Landpro Reference: 24131

Council Reference: RM25.177, RM25.206

**RE: Request for Further Information under Section 92(1) of the Resource Management Act 1991 – Applications RM25.177 and RM25.206 relating to the discharge of treated wastewater and associated activities at QLDC's Shotover Wastewater Treatment Plant (WWTP).**

<b>To</b>	Andrew Hill	<b>Contact No.</b>	-
<b>Copy to</b>	Claire Perkins	<b>Email</b>	-
<b>From</b>	Dusk Mains & Anthony Kirk	<b>Project No.</b>	12645246
<b>Project Name</b>	Shotover WWTP Disposal Field Alternative Discharge		
<b>Subject</b>	RM25.206 & RM25.177 Response to S92 questions

**Figure 4** Shotover River Bowen Peak stage height relationship to estimated braid flow in reasonable mixing zone

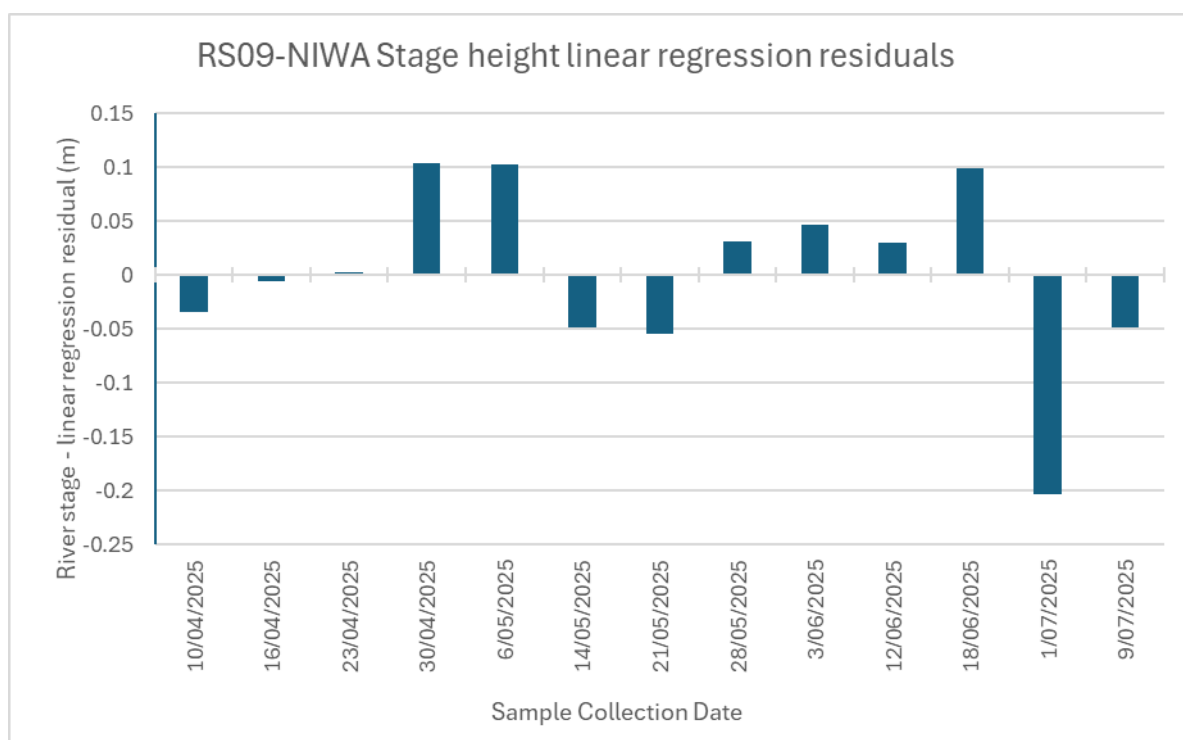
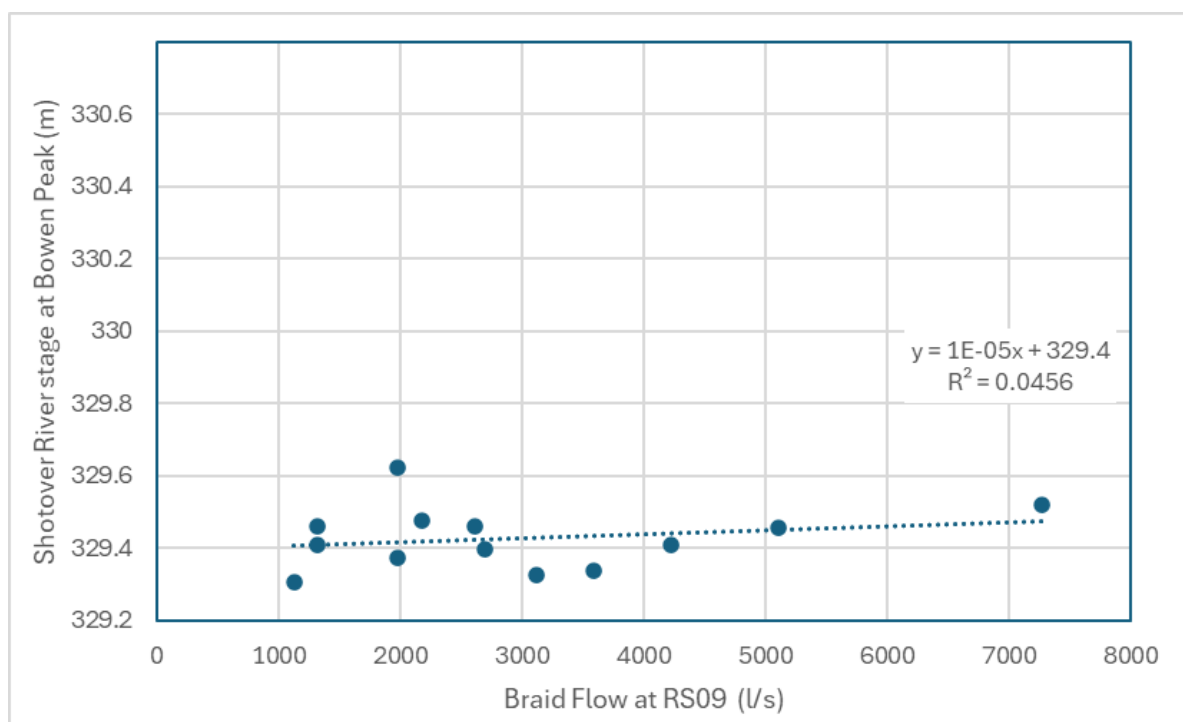
*a. provide an explanation for how the approximate 15-to-25-fold dilution of treated wastewater in the Shotover River/Kimiākau was verified without hydraulic calculations, dye tests or flow modelling to substantiate the dilution assumption and mixing zone extent.*

However, each model had very poor goodness of fit as illustrated in Figure 4, with a coefficient of determination ( $r^2$ ) of less than 0.05. This apparent disconnect between measured river flow and experienced braid flow is discussed in Section 4 and is interpreted to be the result of ever changing sediment deposition and erosion, changing the morphology of individual braids.

**Figure 5** Total phosphorous concentration 2017-2019 monitoring

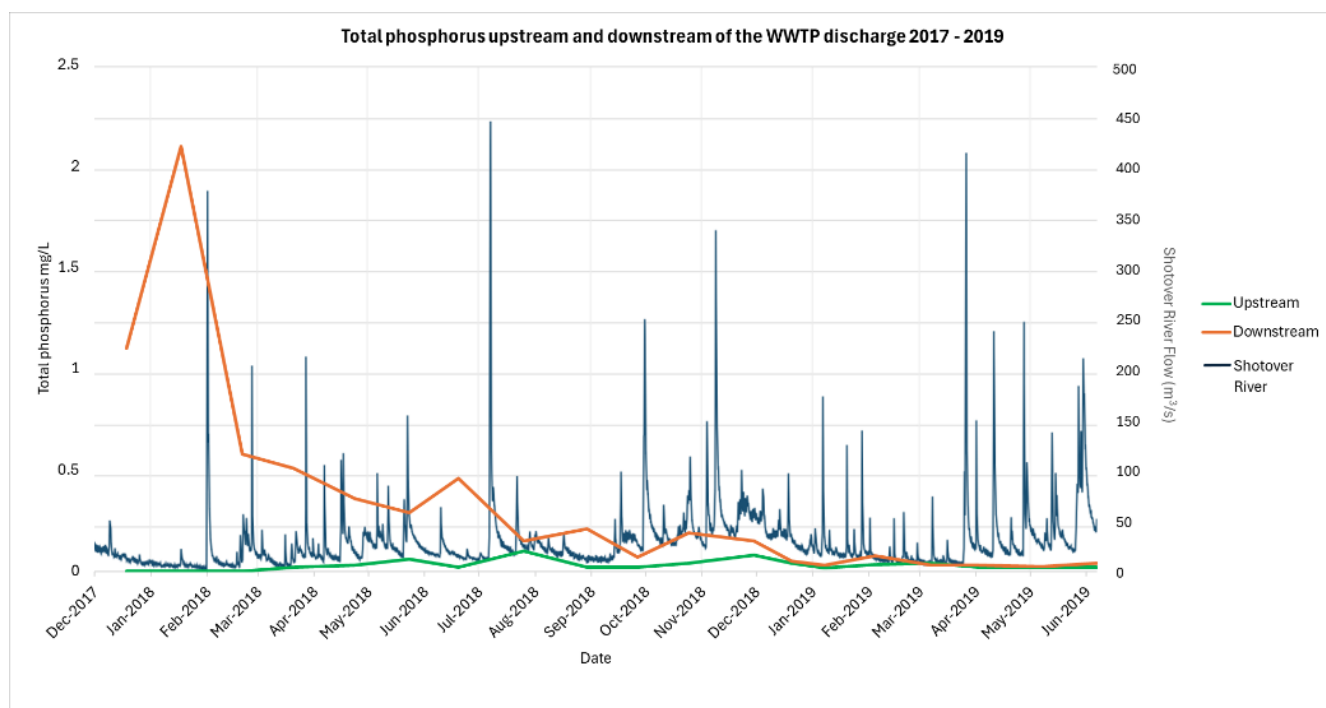
- 9. Please provide an explanation for how a single round or a small number of samples can be considered representative and why further replication was not considered as this would be standard practice.*

In the context of identifying trends for general comment, the progressive reduction in contaminant concentrations (downstream – shown as orange line in **Error! Reference source not found.**5 of Appendix A) is considered to be sufficiently apparent and statistical analysis is considered unlikely to provide additional significant information.

**Figure D.1** Surface water monitoring locations as listed in Table 3.8 in Shotover WWTP Surface water and groundwater assessment

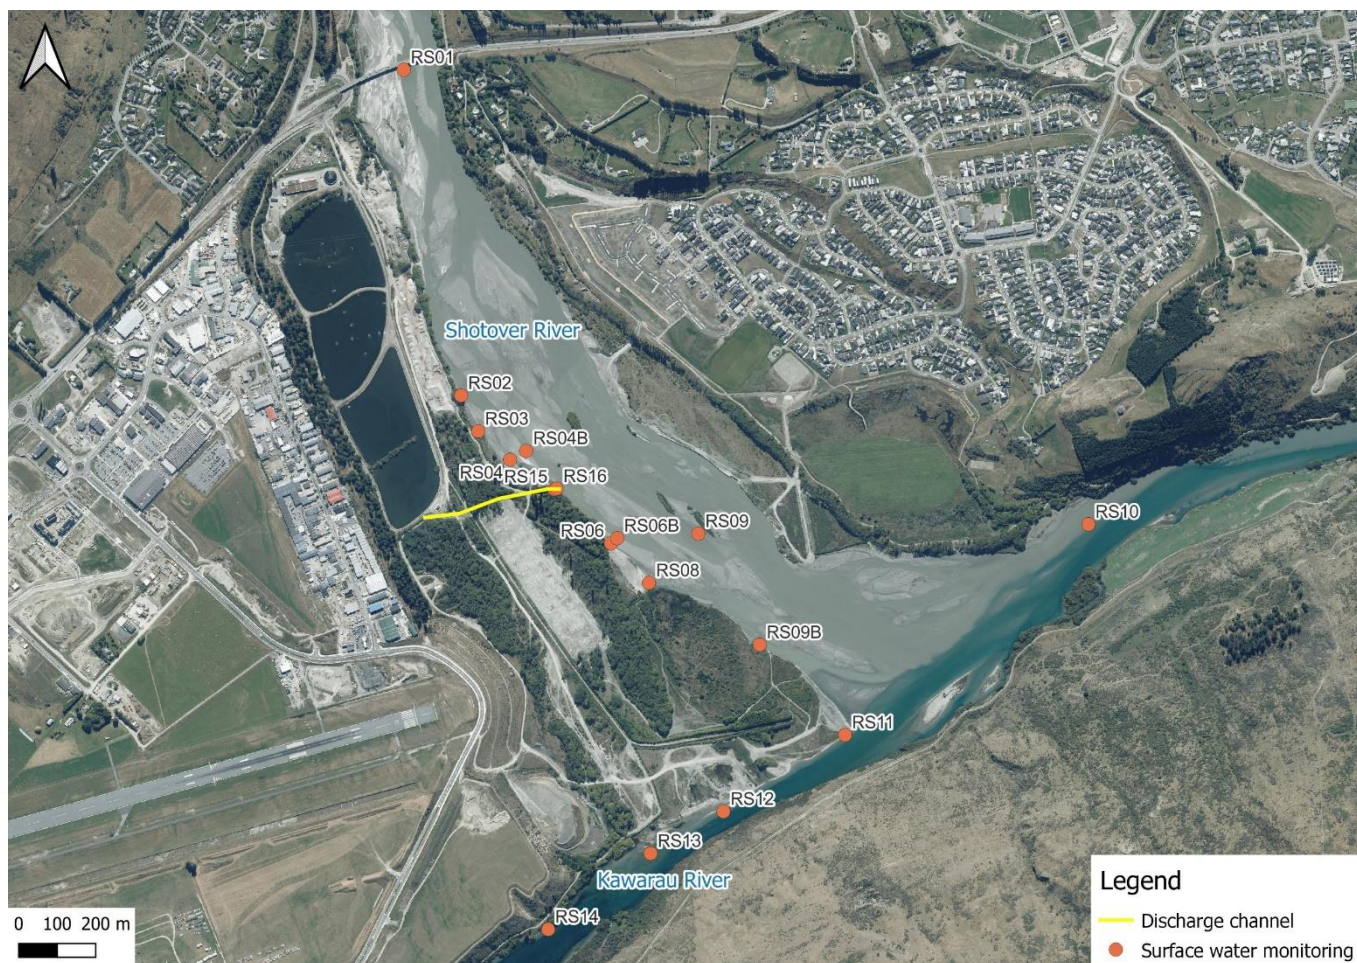
*b. provide a map showing the monitoring sites listed in Table 3.8.*

**Figure 3** Longitudinal section of the proposed protection and diversion system at the discharge point to Shotover River

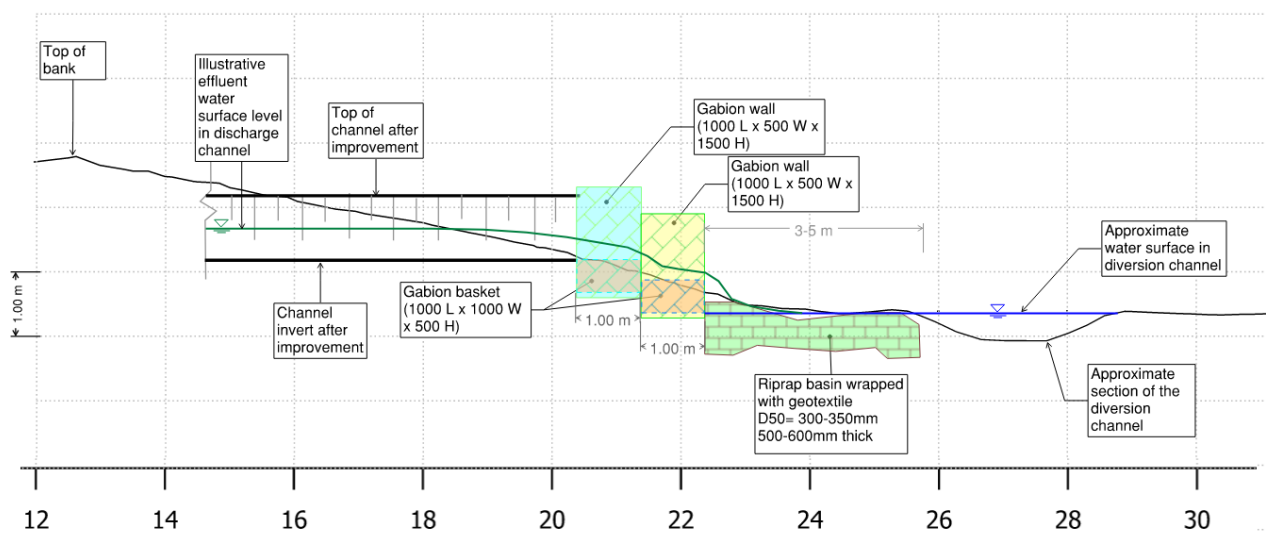
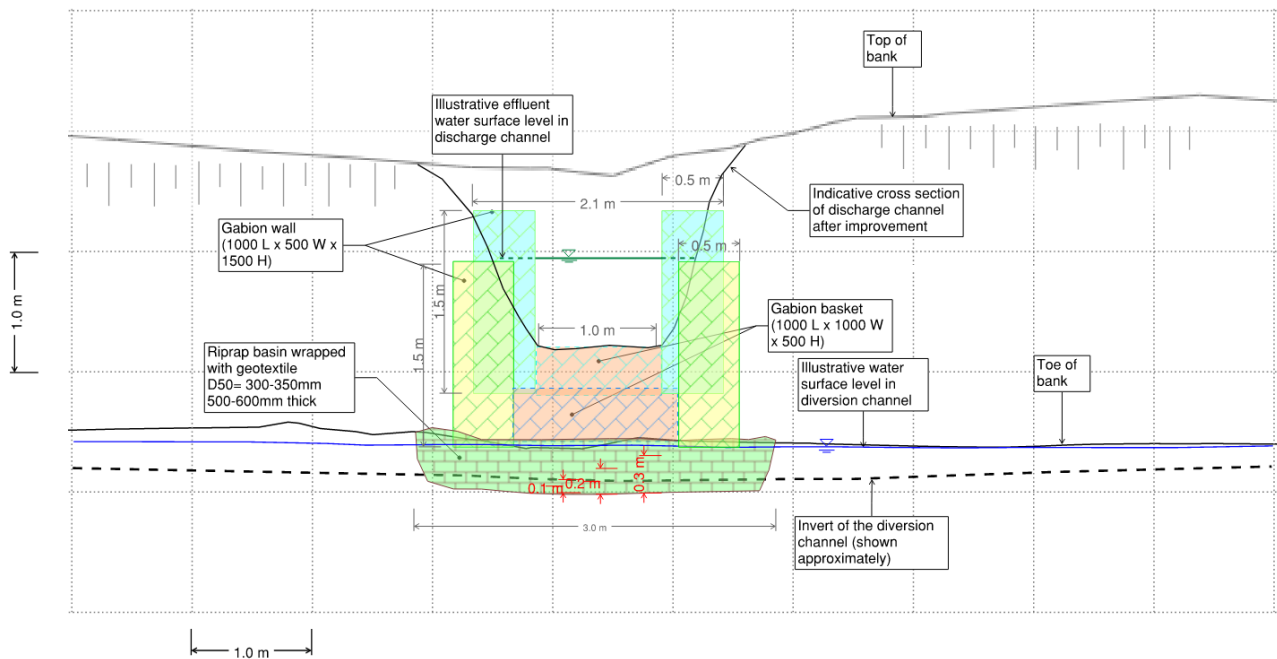
- 15. The following information is requested to validate the technical information provided to support the application for works in the bed of the Shotover River/Kimiākau to construct an outfall structure. Please provide:*
- a. plans or schematics of the discharge outlet structure.*

Please refer to Sections 3 and 4 of **Appendix B** for further details and Figure 3 and Figure 4 of **Appendix B** for a schematic design of the outlet structure.

**Figure 5** Indicative zone of the proposed diversion and flow maintenance

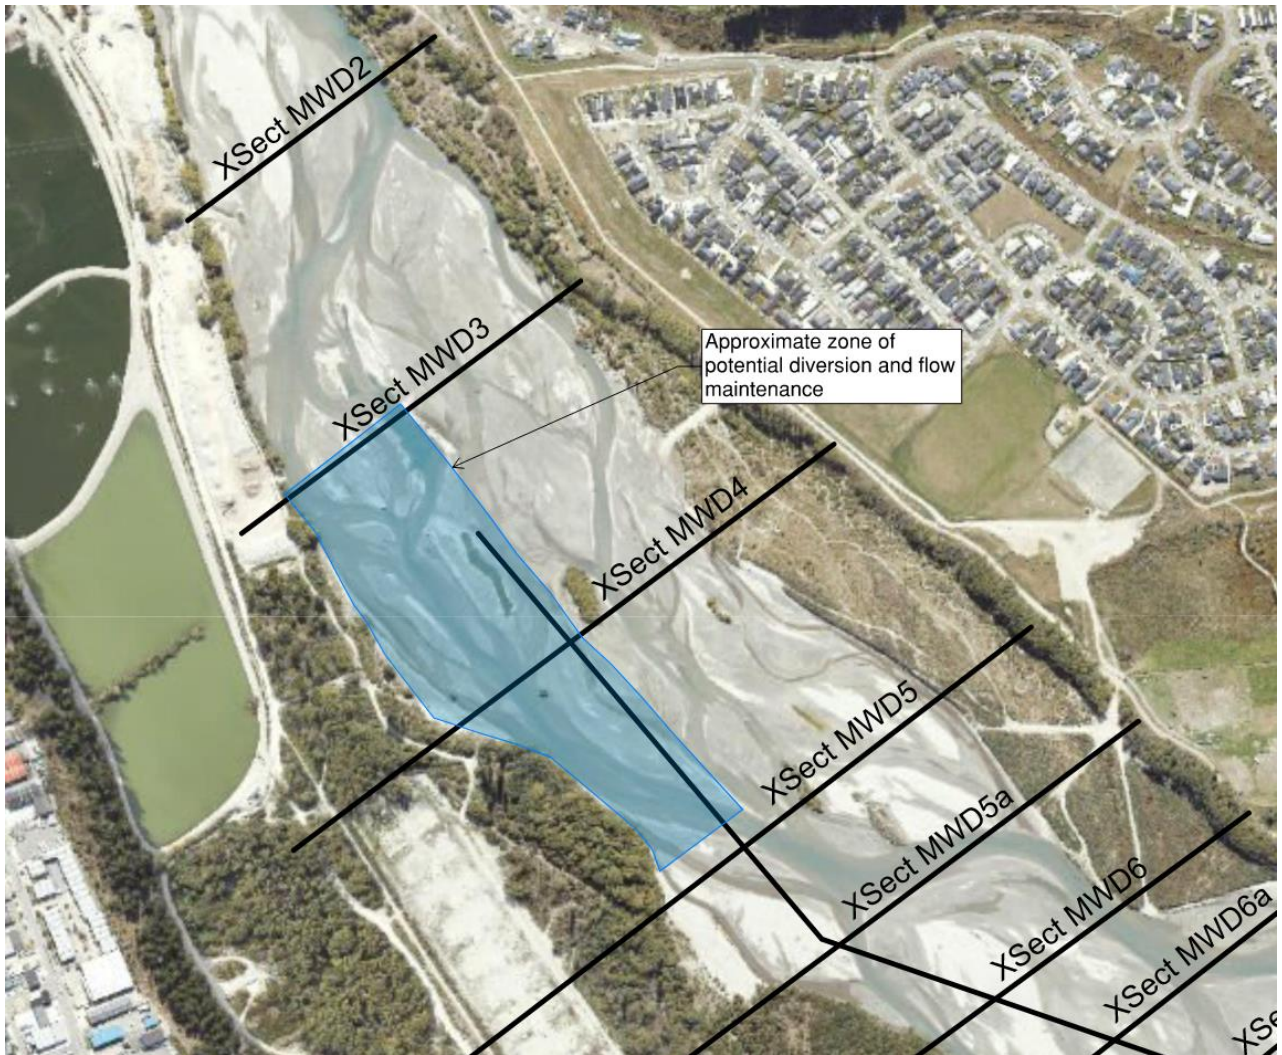
2. *Based on the maximum flow rate proposed in response to Question (1) please provide an assessment of:*
  - a. *Effects on hydrology, morphology and erosion of the bed and bank arising from the proposed diversion of water at the maximum flow rate, including an assessment of effects on the Council's Training Line.*

The proposed work involves excavating a shallow diversion channel from the nearby braid from 300m (approx.) upstream and may extend to approximately 200m downstream of the discharge channel. This will be within the zone shown in Figure 5 of **Appendix B**. The invert of the proposed diversion channel will tie into the invert of the existing braid at both ends.

Figure 1: nMDS ordination plot for the 2017 untransformed macroinvertebrate data by site and replicate for the Shotover River. Axes are identically scaled so that site replicates closest together are more similar in macroinvertebrate composition, than those further apart.

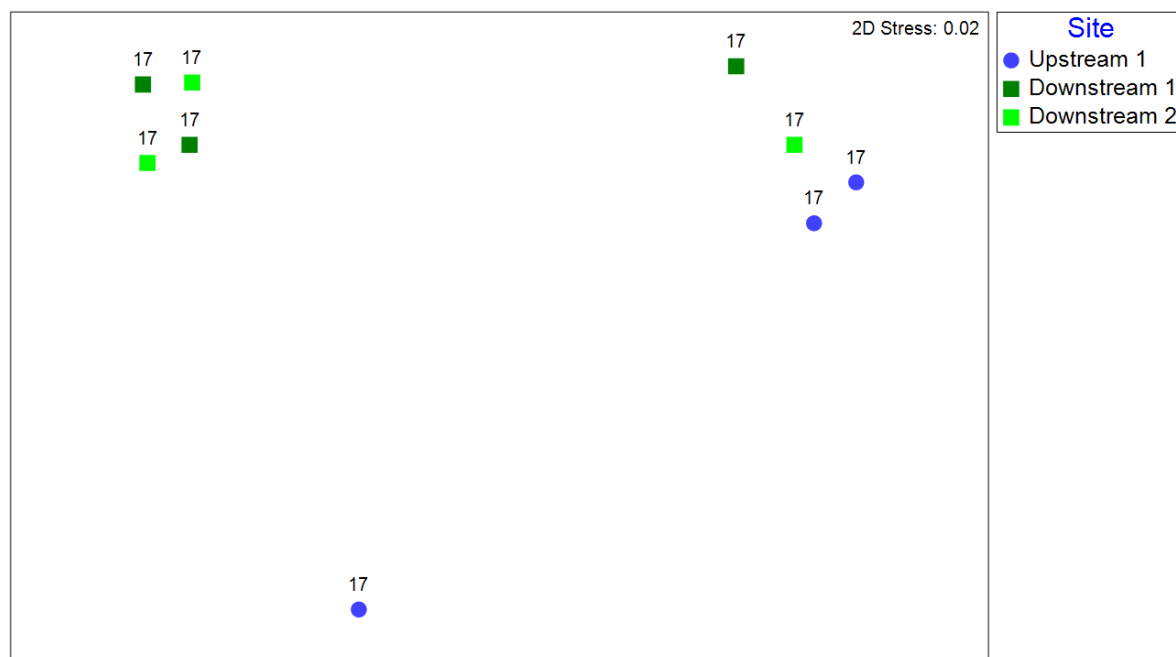
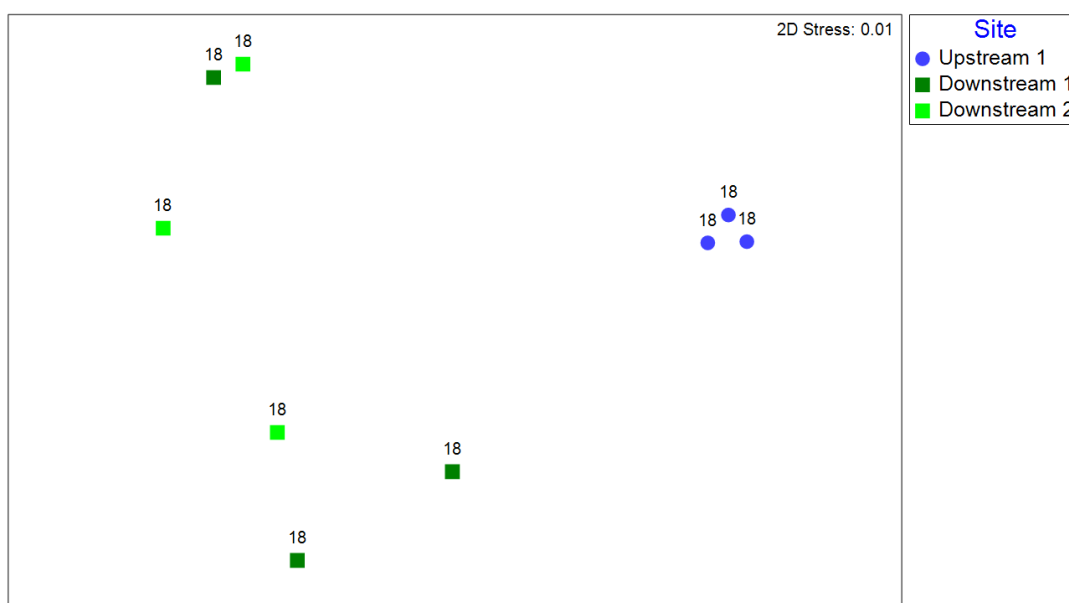
- a. *confirm whether macroinvertebrate monitoring data are available for the period considered representative of the future discharge (2017-2019).*
- b. *provide a spreadsheet with all of the ecological data referenced in Section 3.9.*
- c. *confirm whether standard equivalence testing can be conducted on the QMCI data to statistically test the potential effects of the discharge.*

The PERMANOVA showed there was no significant difference in the macroinvertebrate community between the three sites in 2017 ( $p = 0.32$ ) (as can be seen in Figure 1). However, PERMANOVA showed a significant difference in community composition at the upstream site compared to the downstream sites in 2018 ( $p = 0.03$ ; Figure 2)<sup>1</sup>. A similarity percentages analysis (SIMPER) on the 2018 data indicated that these differences were largely due to differences in the number of occurrences of some taxa (i.e., greater or lesser numbers of individuals). For example, the downstream site replicates typically had higher abundances of *Deleatidium* mayflies, *Zelandobius* stoneflies, Hydropsyche-Aoteapsyche caddisflies and true fly larvae belonging to Orthoclaadiinae, Empididae and Tanytarsini. The higher abundances of these macroinvertebrate taxa at the downstream sites in 2018 may be associated with the slightly higher thin periphyton and short filamentous algae cover also recorded at the downstream sites in 2018 compared to the upstream site (refer to response d. below and Figure 3), which could influence the macroinvertebrate community.

Figure 3: Periphyton percentage cover at the upstream, downstream 1 and downstream 2 sites in the Shotover River compared to the Biggs (2000) guideline values in February 2017 (top) and January 2018 (bottom), copied from Ryder (2017) and Ryder (2018), respectively.

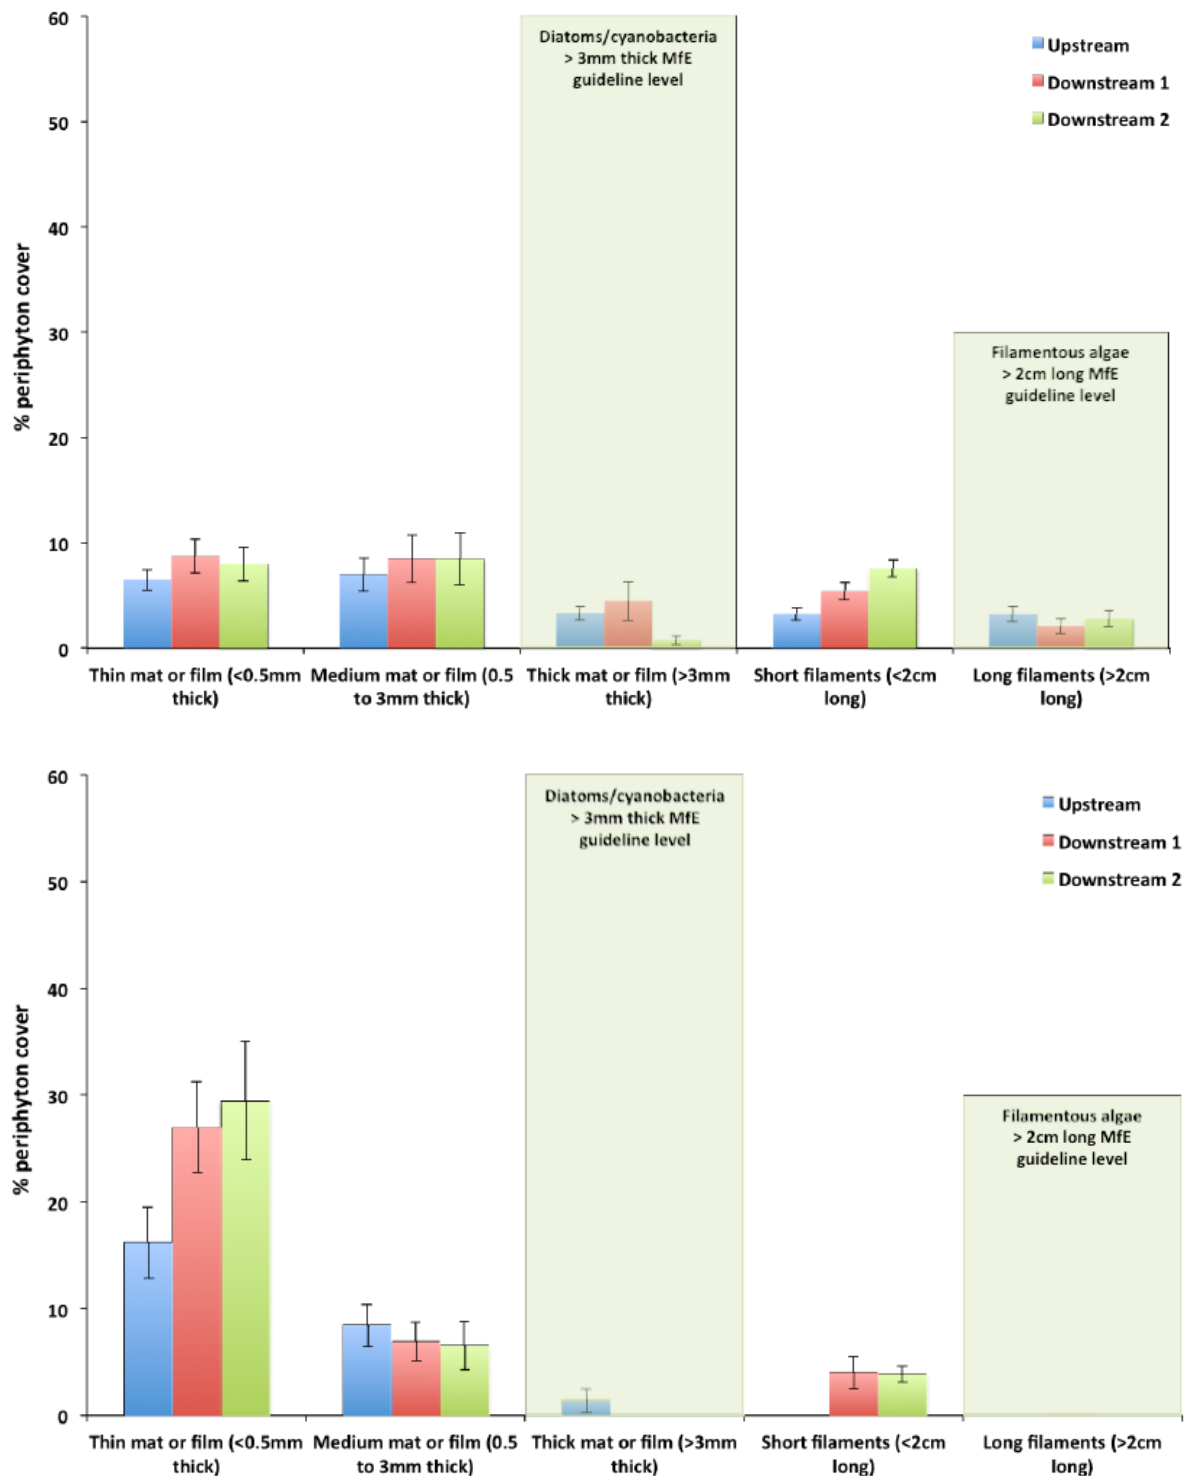
*d. provide all available periphyton data and an explanation on whether heterotrophic growths have been monitored and if they have, whether they have been detected. I note that this is specifically mentioned in the Kawarau River Water Conservation Order (WCO).*

The historical monitoring shows that periphyton cover is also often low downstream of the discharge. The percentage cover of diatoms / cyanobacteria and filamentous algae recorded during the monitoring has consistently been well below the guideline values (Biggs, 2000), as can be seen for the 2017 and 2018 results included below (Figure 3).

Heterotrophic growth has not been reported in the visual assessments conducted by others during this annual monitoring in late summer / early autumn and is not apparent in photographs taken during the monitoring (Figure 4 and Figure 5).
